Tipton Meeting House/Completion Phase
Project No. FM100106L/981350
Addendum No. ONE

February 3, 2010

ADDENDUM NUMBER 1

SK-001

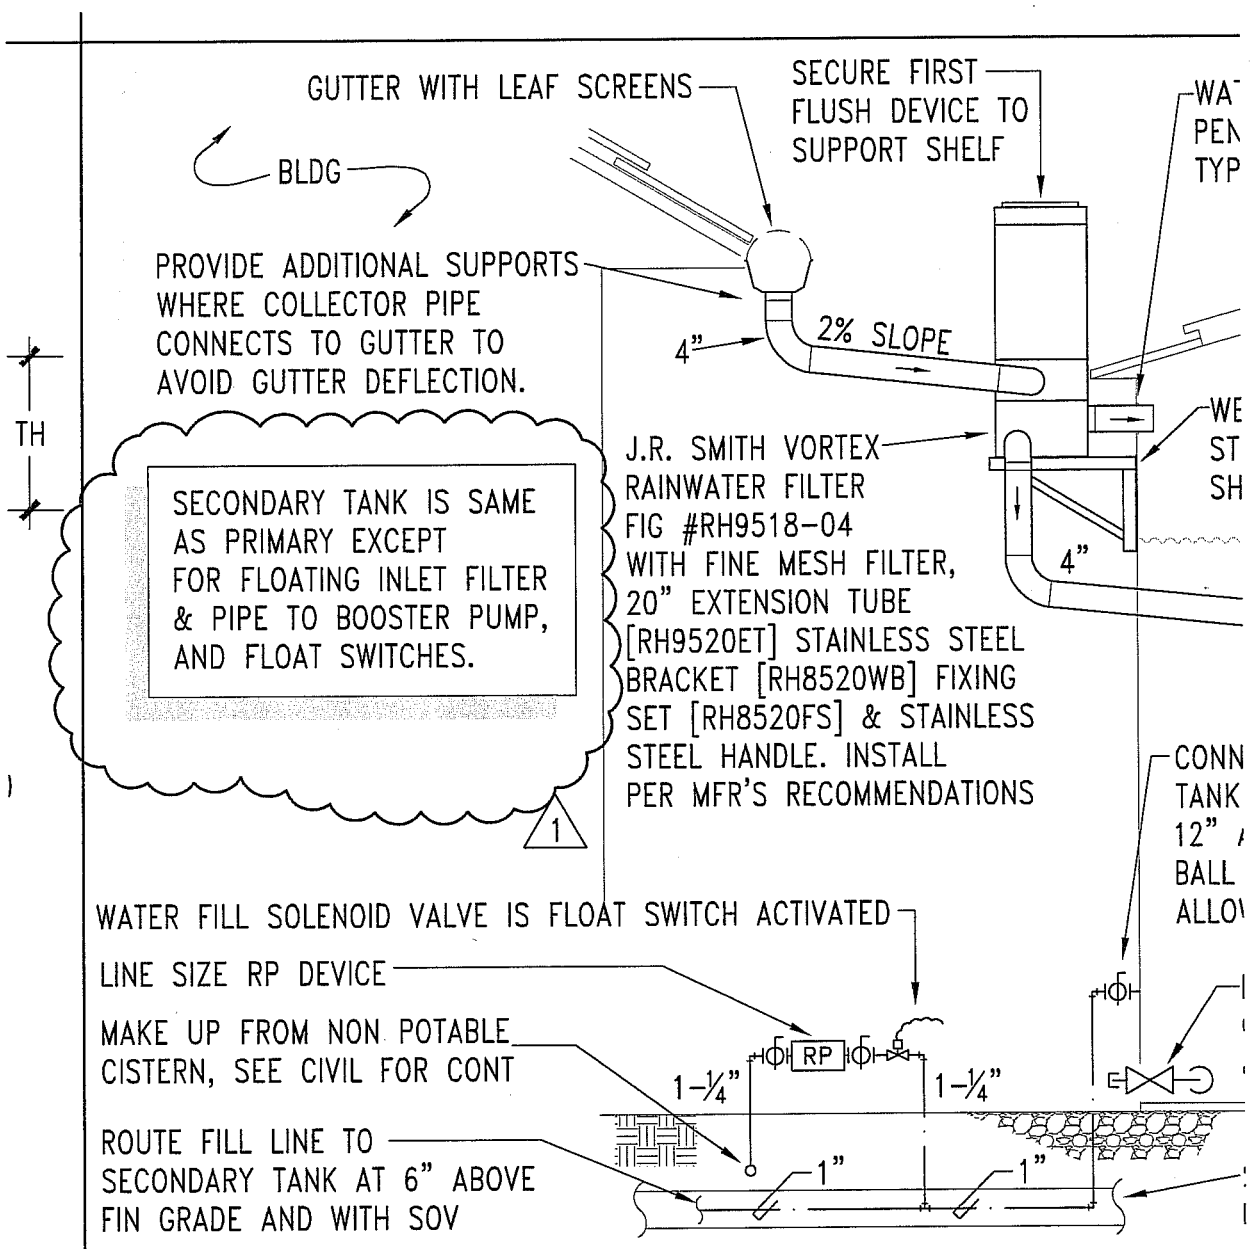
2. P1.1, Abbreviations, Symbols & Schedules, Detail 4, Primary Rainwater Catchment Tank, Note beginning with "Secondary Tank...": **CHANGE** to read as shown in the attached sketch, **SK-001, Portion of Detail 4/P1.1 Revised, Dated February 2, 2010:**
"Secondary tank is same as primary except for floating inlet filter & pipe to booster pump and float switches."
